MEDWAY EPFRAC MEETING Medway High School (Guidance Area) 7:00 PM Minutes December 20th, 2016

The agenda for the EPFRAC meeting: to discuss the results of Public Input Session and Survey for Parks and Playgrounds Improvements Project (Choate Park, Cassidy Field, Middle School, Oakland Park) as well as discuss the goals and objectives for Parks and Playgrounds Improvements Project.

MEDWAY MIDDLE SCHOOL
Medway, MA
SCHEMATIC DESIGN - OPTION A

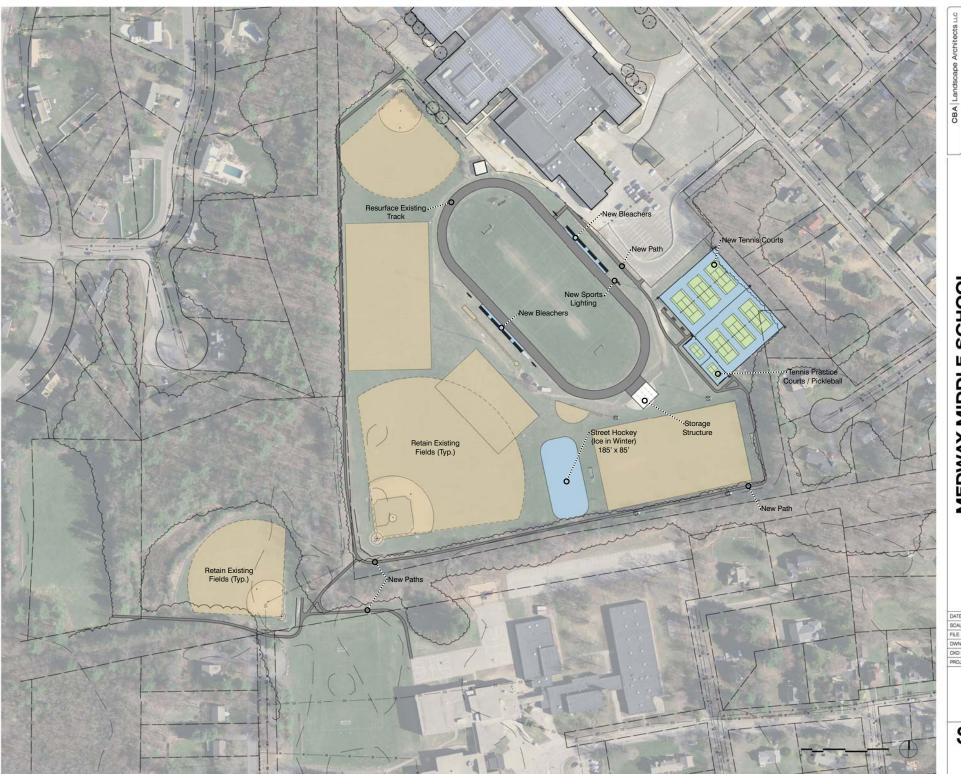
Design Option A:

- 185x85 street hockey rink (ice in winter) abutting track
- Storage structure near tennis courts
